BULLETIN NUMBER:
SB13-04-S001A

SAFETY RECALL 12V-406

DRIVER DOOR SWITCH SHORT CIRCUIT

This service procedure has been revised. The procedure for applying the protective coating on the door module has been removed. Please discard previous bulletin SB13-04-S001.

Figure 1 – Driver Side Door Lock & Side Window Switch

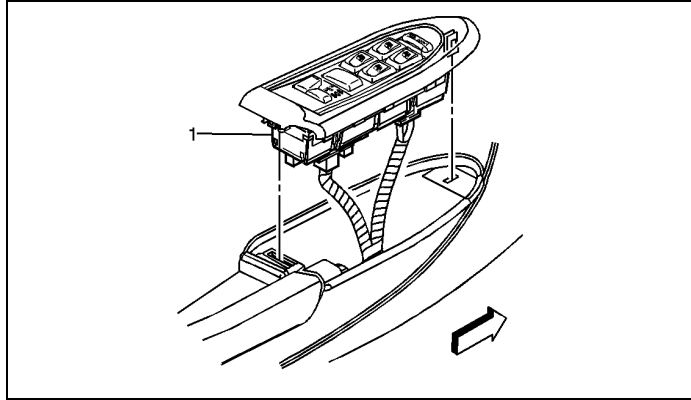
1. Remove the driver side door lock and side window switch. Refer to *Door Lock and Side Window Switch Replacement - Driver Side* in the service manual.

2. Determine the part number on the driver side door lock and side window switch. The part number is on the side of the switch on the label.
 - a) If the part number on the switch is listed in the parts table, no repair is required. Re-install the driver side door lock and side window switch. Refer to *Door Lock and Side Window Switch Replacement – Driver Side* in the service manual, and then proceed to Step 3, “Applying the Campaign Label”.

- b) If the part number on the switch is NOT listed on the table above, replace the driver side door lock and side window switch. Refer to *Door Lock and Side Window Switch Replacement – Driver Side* in the service manual.
